NUMBER: 08-054-05

Ambient Temperature Reads Higher Than Actual

This bulletin involves moving the ambient temperature sensor to a new location.

2006 (XK) Commander

Fig. 1 AMBIENT TEMP SENSOR HARNESS

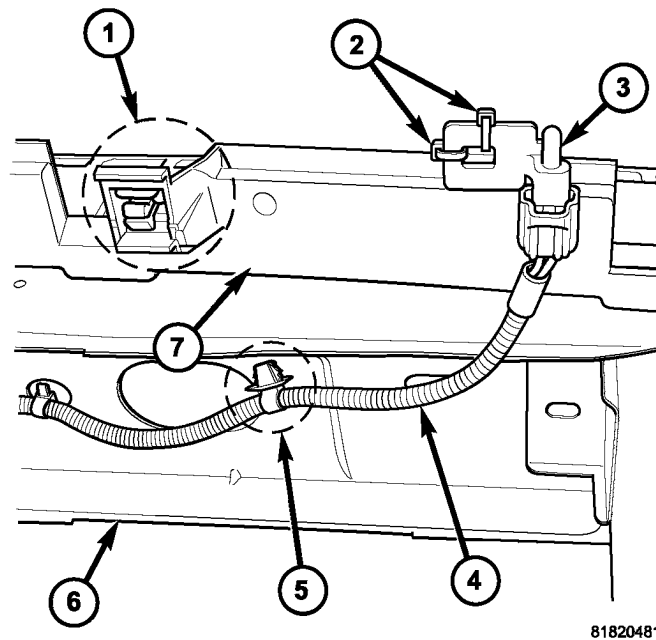
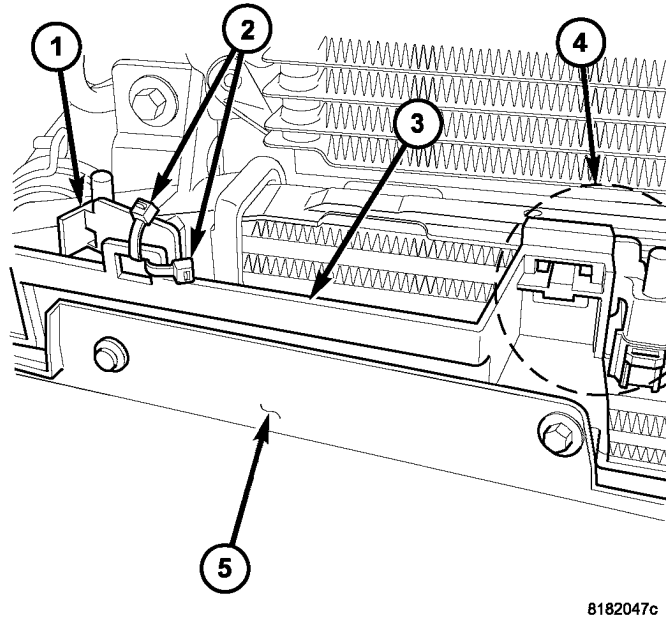
This condition may be caused by the original location of the ambient air temperature sensor. The sensor may be too close to the radiator and other heat exchangers.

-
4. Detach (unclip) the ambient temperature sensor from the front fascia support. The ambient temperature sensor will be relocated outboard (towards the right side) from its original location by approximately 5 inches.

- 1 - Original (Old) Location Of Ambient Air Temperature Sensor
- 2 - Two Plastic Tie Straps Required To Hold Sensor In Correct Position
- 3 - Ambient Air Temperature Sensor - New Location
- 4 - Ambient Air Temperature Sensor Harness
- 5 - Harness Clip - Detach (Unclip) From Front Crossmember
- 6 - Front Metal Crossmember
- 7 - Front Fascia Support Panel

6. Secure the ambient temperature sensor to its new location on the front fascia support. Attach the sensor to the fascia support using two plastic tie straps. The plastic tie straps must be located 90° from each other (one strap positioned horizontally, and the other strap positioned vertically). Verify that the tie straps are snug to the sensor and fascia support panel.
